I2 Structural Requirements for Polar Class Ships

(August 2006)
(Rev.1 Jan 2007)
(Corr.1 Oct 2007)
(Rev.2 Nov 2010)

Figure 1 - Hull Area Extents

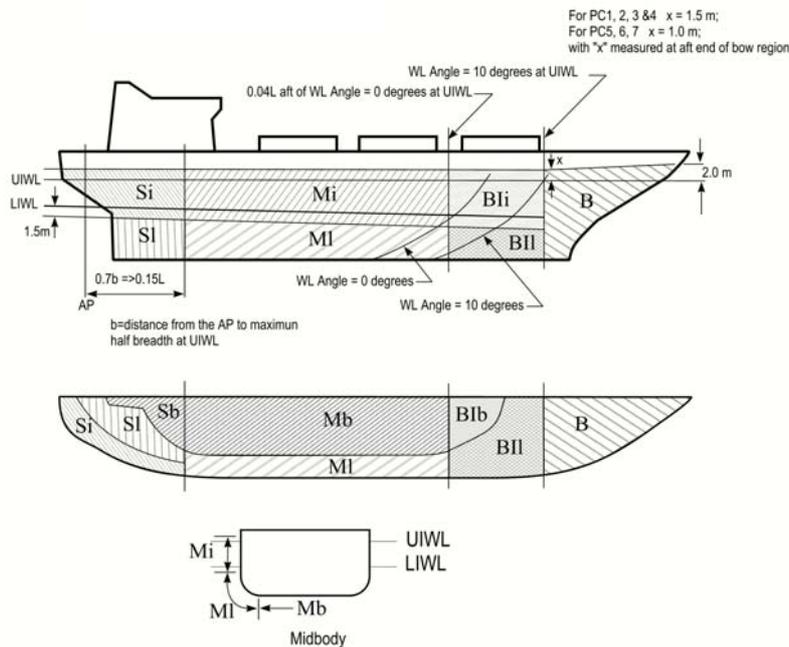
Deleted: I2.2.3 Figure 1 notwithstanding, at no time is the boundary between the Bow and Bow Intermediate regions to be forward of the intersection point of the line of the stem and the ship baseline.¶

12.2.3 Figure 1 notwithstanding, at no time is the boundary between the Bow and Bow Intermediate regions to be forward of the intersection point of the line of the stem and the ship baseline.

12.2.4 Figure 1 notwithstanding, the aft boundary of the Bow region need not be more than 0.45 L aft of the forward perpendicular (FP).

Figure 4 - Stiffener geometry

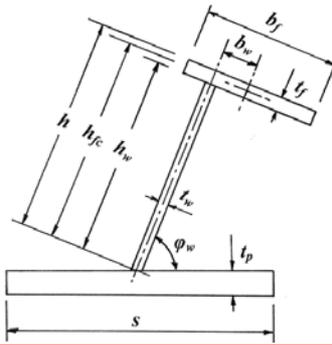
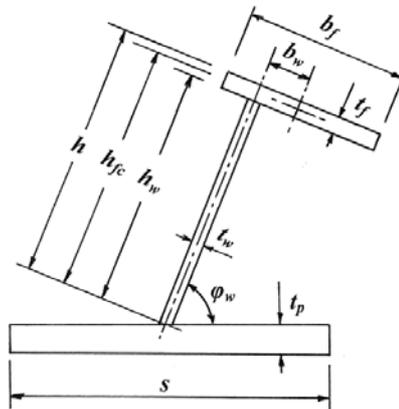
A_{pn} = net cross-sectional area of **the local frame**, [cm²]

Deleted: attached plate

Deleted: (equal to $t_{pn} \cdot s \cdot 10$, but not to be taken greater than the net cross-sectional area of the local frame)

Figure 5 - Parameter Definition for Web Stiffening

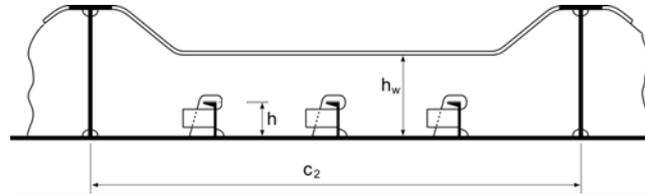
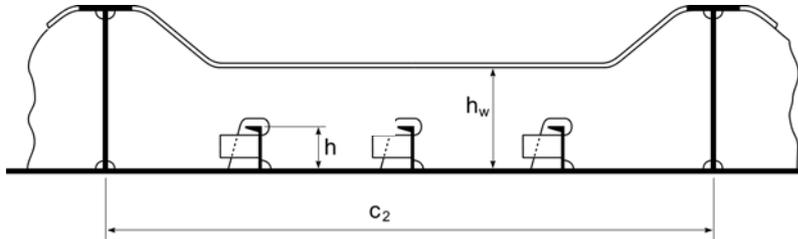
$$t_{wn} = 2.63 \times 10^{-3} \cdot c_1 \sqrt{\sigma_y / (5.34 + 4 \cdot (c_1 / c_2)^2)} \text{ [mm]} \quad \text{[Equation 26]}$$

where c₁ = h_w - 0.8 · h [mm]

- Formatted: Lowered by 5 pt
- Formatted: Lowered by 8 pt
- Deleted: ¶
- Deleted: x
- Deleted: 10⁻³ ·
- Deleted: *
- Deleted: c₁ ·
- Deleted: *
- Deleted: (σ_y / (5.34 + 4 ·
- Deleted: *
- Deleted: (c₁ / c₂)²)^{0.5} [mm] · [Equation 26]¶
- Formatted: Superscript
- Deleted: *
- Deleted: 1
- Deleted: 2007
